VARIANCE APPLICATION

Project/Property Address or Location: Buckles Court North (Lot 4)		Project Name/Business Name: Lot 4 MOB	
Parcel ID No.(s): 025-013813-00	Zoning Designation: SCPD	Total Acreage: 1.57 acres	
Description of Variance Requested: 1167.18(c)(1) – trash receptacles must be located to the rear of the primary structure.			
STAFF USE ONLY – Code Section(s): 1167.18(c)(1) – Screening of Trash Containers or Receptacles			
APPLICANT Name-do <u>not</u> use a business name: Larry Canini		Applicant Address: PO Box 887, New Albany, OH	
Applicant E-mail: larry@caniniassocltd.com		Applicant Phone No.: 614-855-4545	
BUSINESS Name (if applicable): Walnut Creek MOB III			
ADDITIONAL CONTACTS Please List Primary Contact for Correspondence (please list all applicable contacts)			
Name(s):		Contact Information (phone no./email):	
Civil & Environmental Consultants, Inc Brian Burkhart, PE		614-315-7172 bburkhart@cecinc.com

RE: Buckles Court (Lot 4) MOB Variance

PLANNING COMMISSION STAFF REPORT

FINAL DEVELOPMENT PLAN
DRAWING NO. **C200**
SHEET 1 OF 1

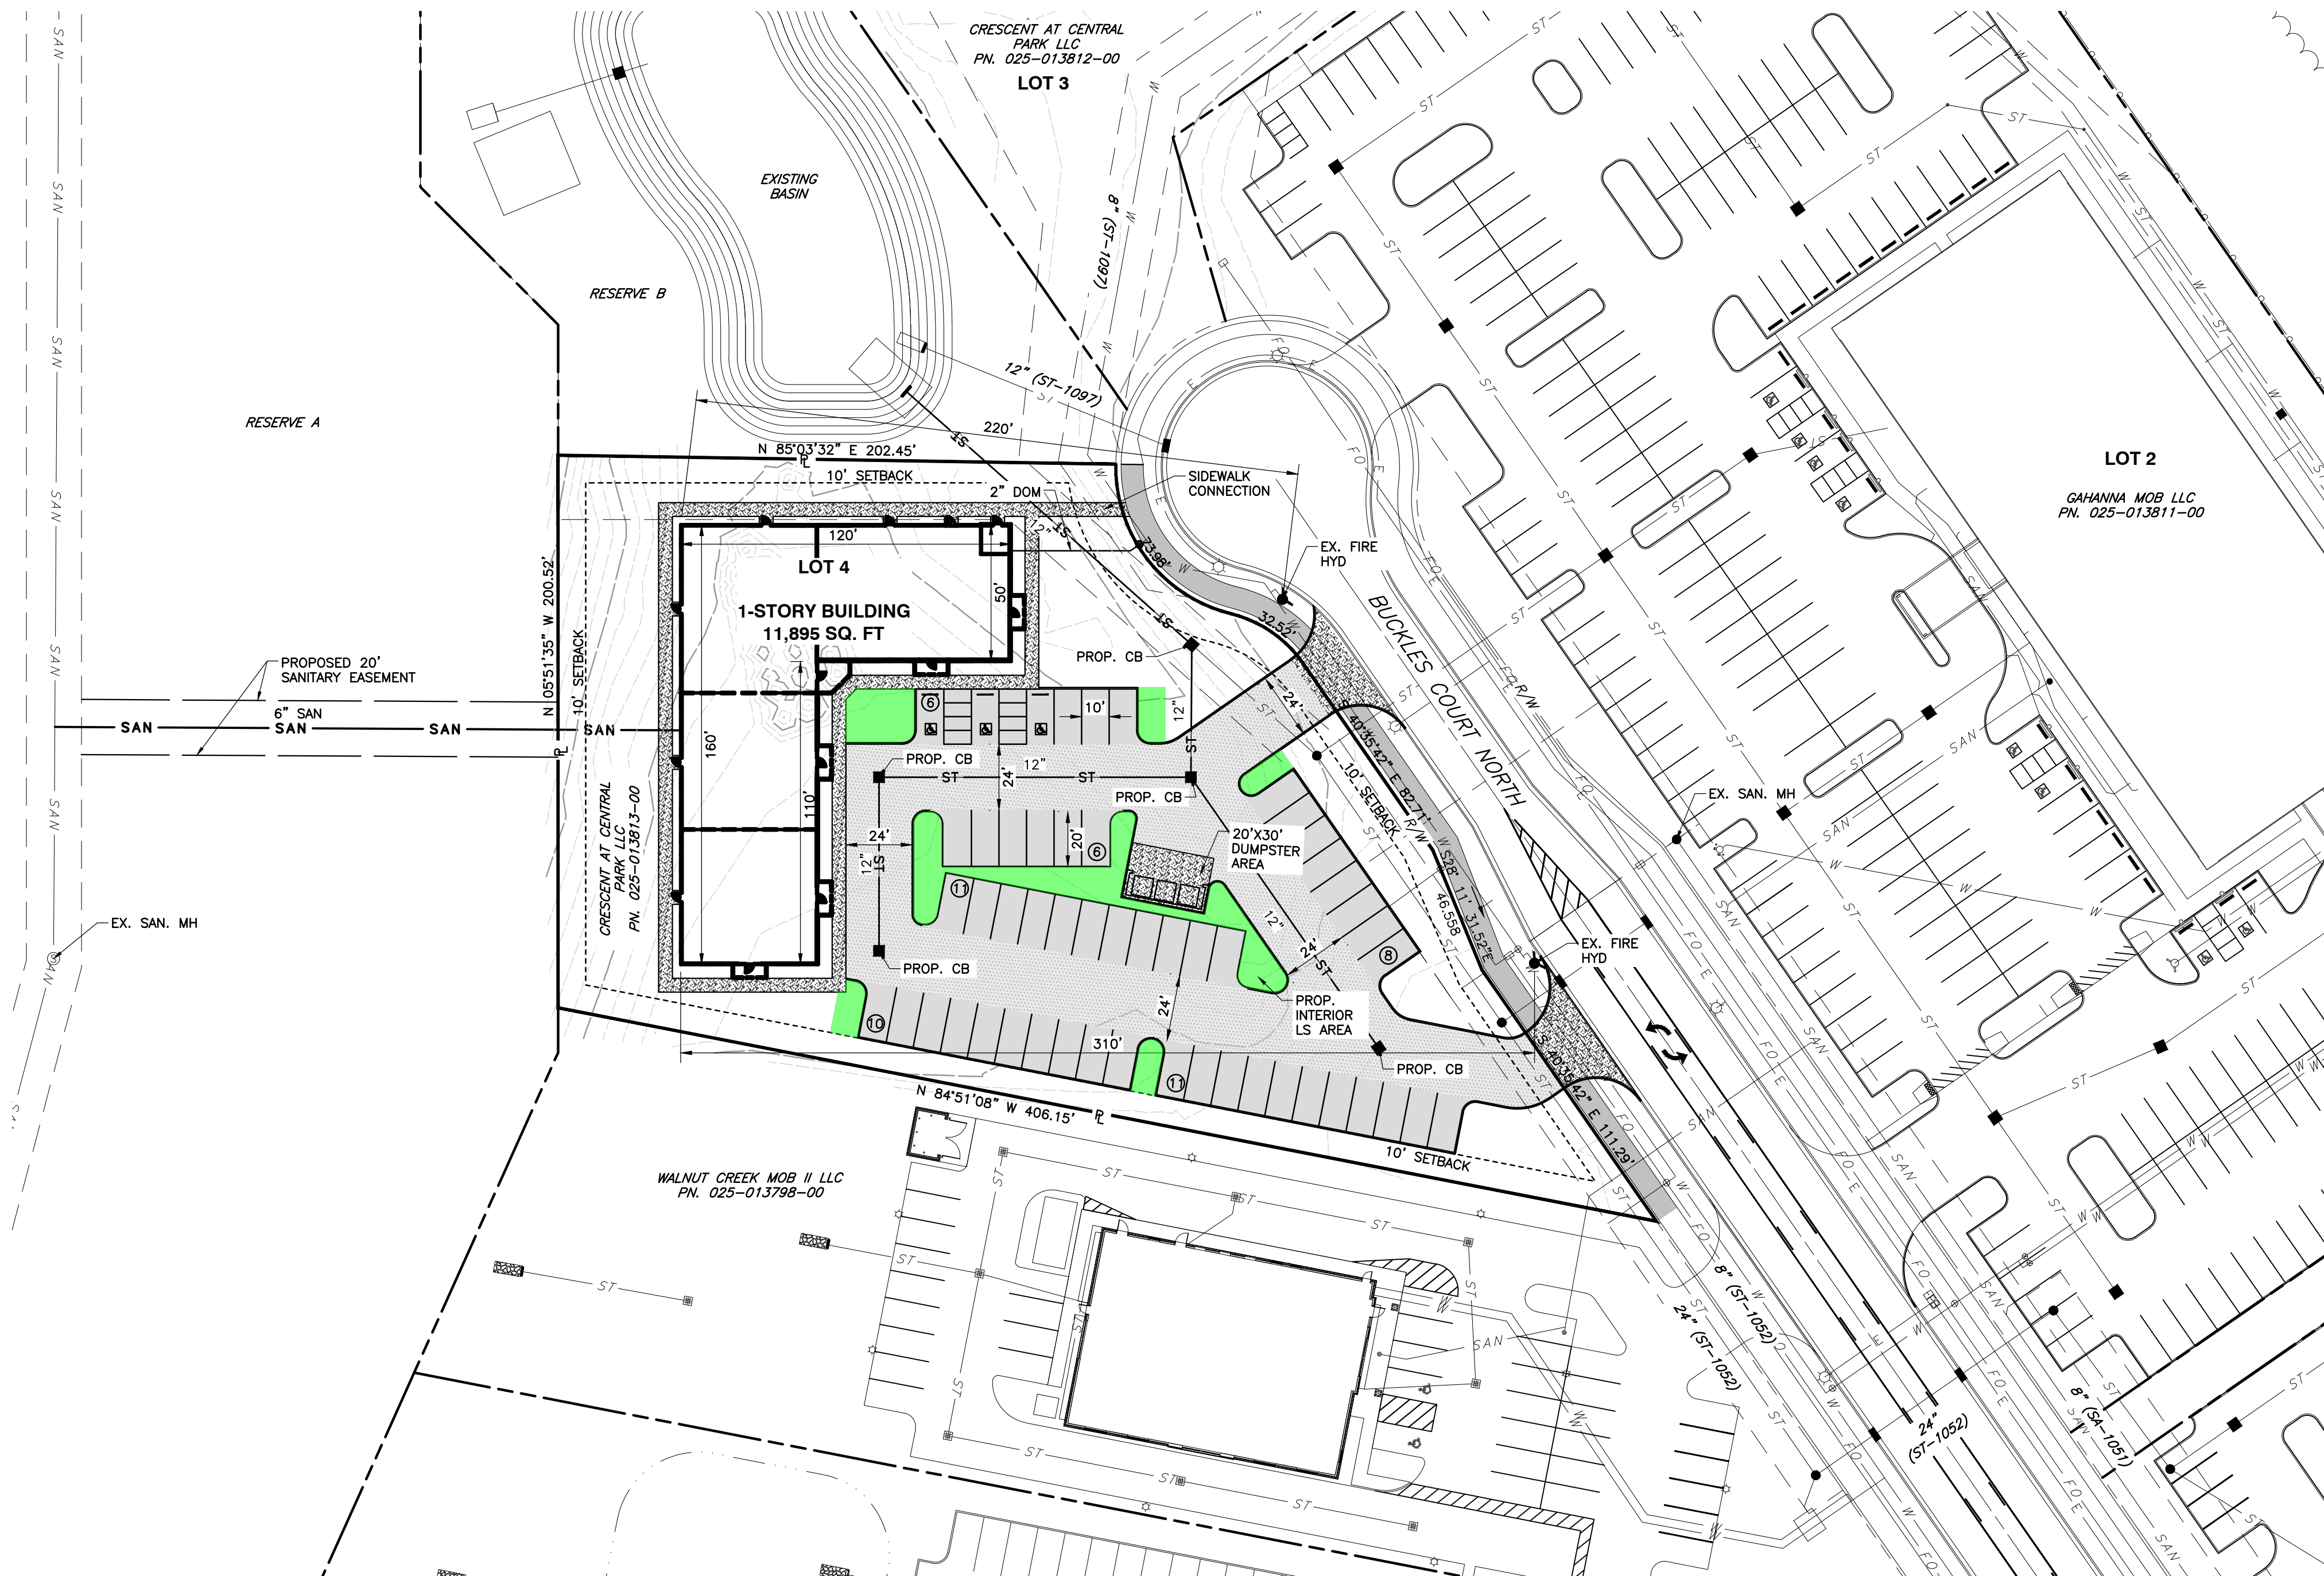
1. Please provide further justification for the requested variance. The current statement is insufficient.
A new variance is being requested for dumpster placement. The previous variance is no longer being requested.

2. It appears that the requested variance may not be required. There is sufficient room on-site to meet the landscaping requirements in both Ch 914 and Ch 1163.08, specifically to the rear of the main structure and in the northeast area of the lot. 1163.08 only requires 13 trees on the site in addition to the required 41 caliper inches. Any tree located in or around the parking area counts towards the 13 trees. There are already 11 trees on the landscape plan that count towards the 13. The application states that the reason for this request is to meet parking requirements, yet the parking count is 9 spaces above the minimum requirement. Additionally, existing trees could be counted towards the required 41 caliper inches. Please revise the proposal to meet Ch 1163.08 requirements or address all of these concerns in the variance statement.
This variance is no longer being requested.

6. I can see that space appears to be limited for the one tree per 100 square feet for interior landscaping requirement. However, I believe more trees can be planted than are included on the plans. I'd like to see an effort to include more trees especially since many trees are proposed to come down as part of this project.

Additional trees added to the plan to meet code requirements.
